Plant/Facility Name **OCONEE NUCLEAR STATION, UNITS 1, 2, AND 3**

Purpose of Meeting
(copy from meeting notice) **TO DISCUSS NON-SEISMIC PIPING IN THE**

OCONEE AUXILIARY BUILDING

Auxiliary Building Flooding Licensing Amendment Request – RAI Responses

Spectral Displacement Comparison

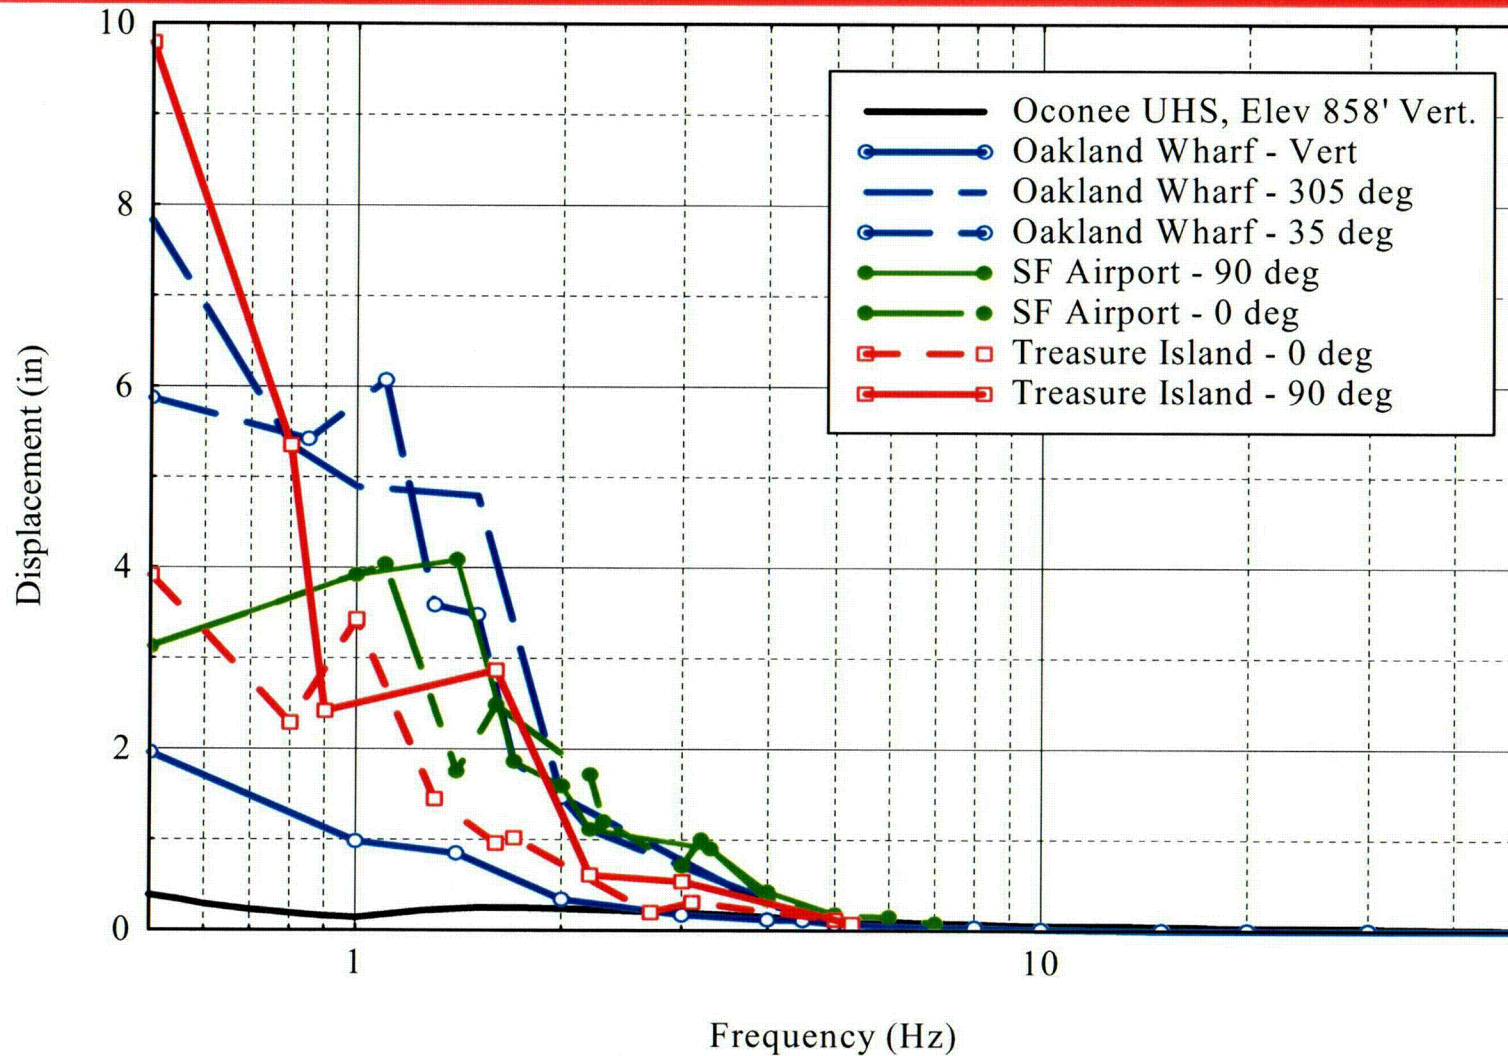
- Received follow-up questions on 2/13/03 and 3/6/03
- Responded on 4/3/03
- Key outstanding issues from conference call on 4/10/03
 - Haven't shown experience is applicable to ONS piping
 - Experience vertical spectrum doesn't envelope ONS UHS spectrum at high frequencies
 - Uncertainty for the analysis case seems unreasonably high
 - Reports of corrosion problems

High frequency
input does not
excite low
frequency
modes

- Analysis of multi-degree of freedom systems shows that
 - response (amplification, stress, etc) is typically dominated by lower frequency modes where
 - the majority of the system mass is vibrating
 - participation factors are largest
- Higher frequency modes have low participation and do not significantly contribute to displacements and stresses

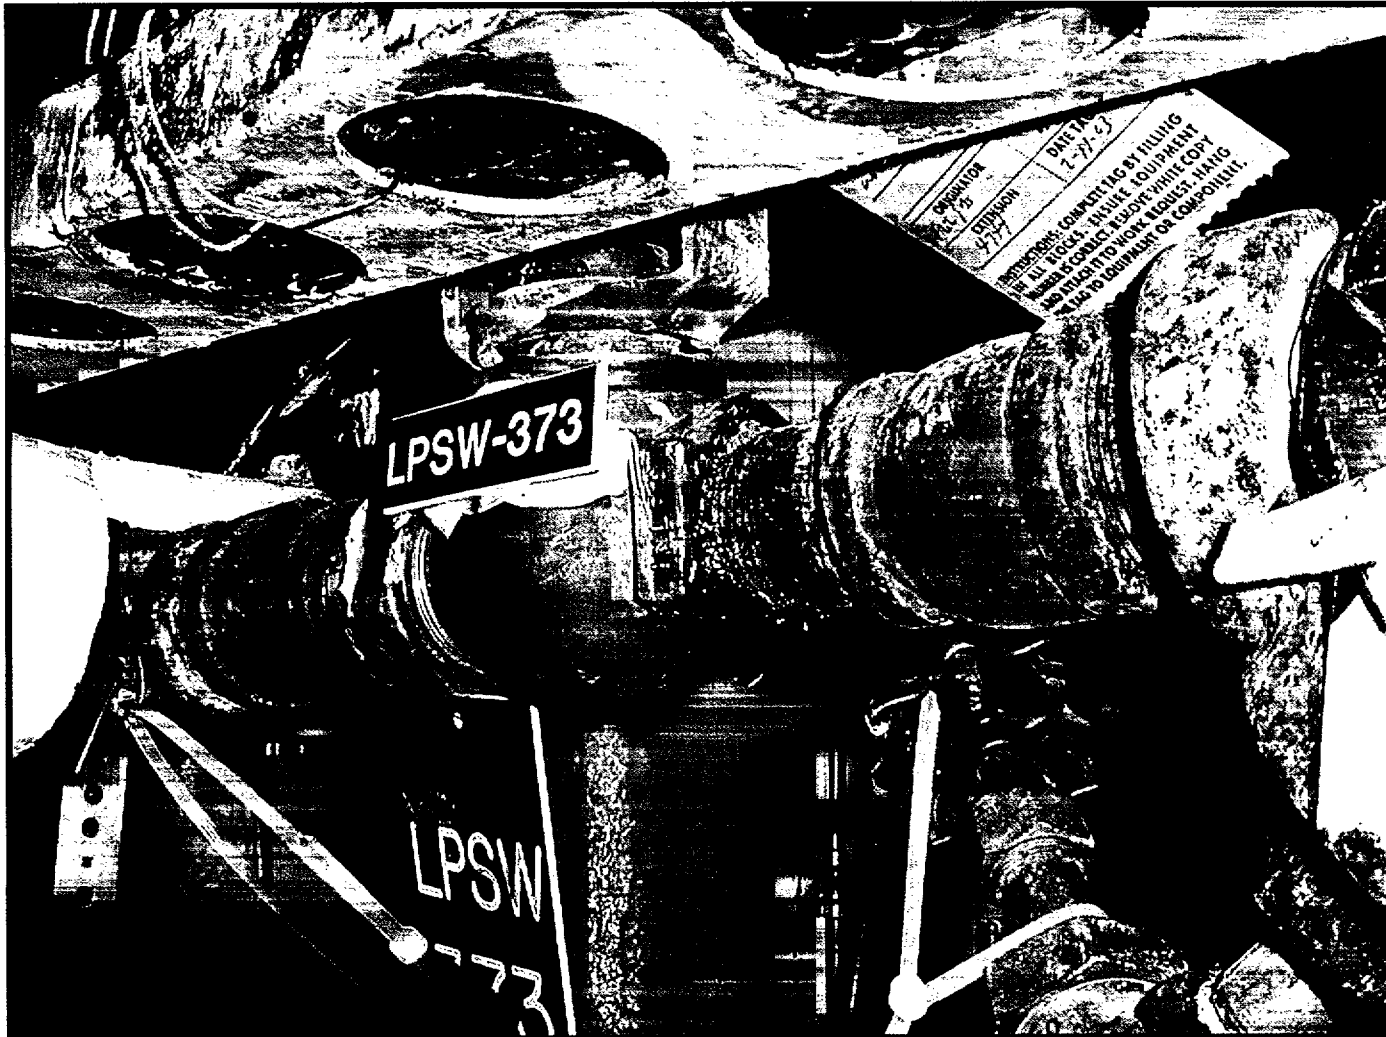
- Corrosion concerns from conference call on 4/10/03
 - Picture of valve LPSW-373 which shows corrosion
 - Question regarding leaks in system
 - Question regarding piping replacement

■ Internal Pitting

- Lake water (clean by most standards)
- Crud Corrosion Products collect over many years of operation

■ LPSW surface corrosion

- Anti sweat insulation
- Anti corrosion paint
- Moisture intrusion over many years
